STATE OF NEBRASKA
DEPARTMENT OF ROADS
ADDENDUM NO. 2
AND
ELECTRONIC BIDDING SYSTEM
AMENDMENT NO. 1
PROJECT NO. STPD-8-7(113)
CONTROL NO. 12773
CALL NO. 105
N-99/N-8, BURCHARD SOUTH
LETTING DATE: NOVEMBER 3, 2011

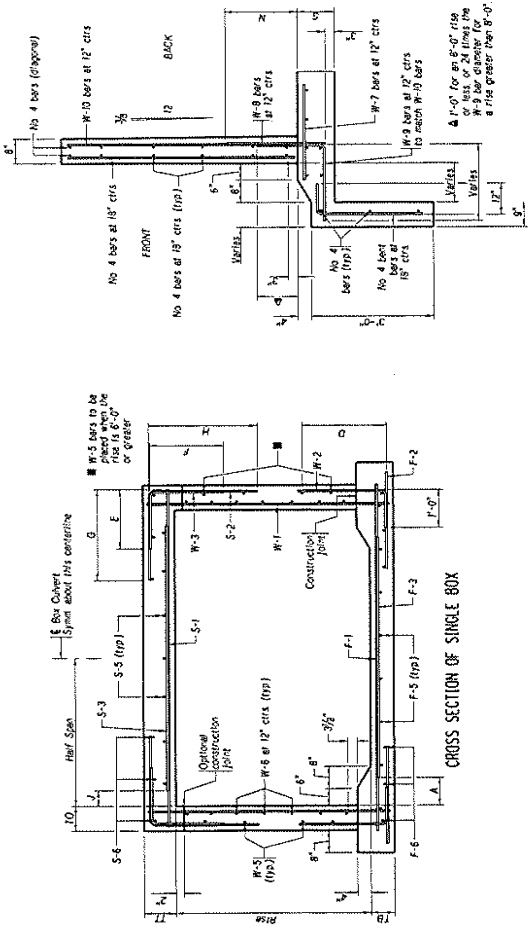
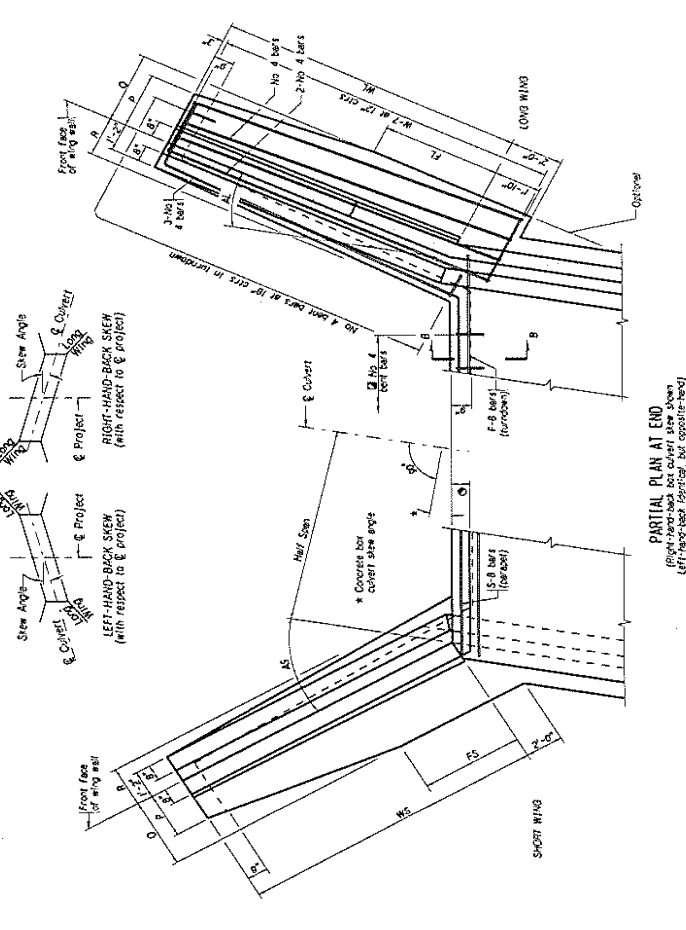
Plan sheets 13 and 14, Special Plan 1C, are void and superseded by added plan sheets 13A and 14A as depicted on the attached sheets.

Plan sheets 16 and 17, Special Plan 3C, are void and superseded by added plan sheets 16A and 17A as depicted on the attached sheets.

Plan sheets 18 and 19, Special Plan 4C, are void and superseded by added plan sheets 18A and 19A as depicted on the attached sheets.
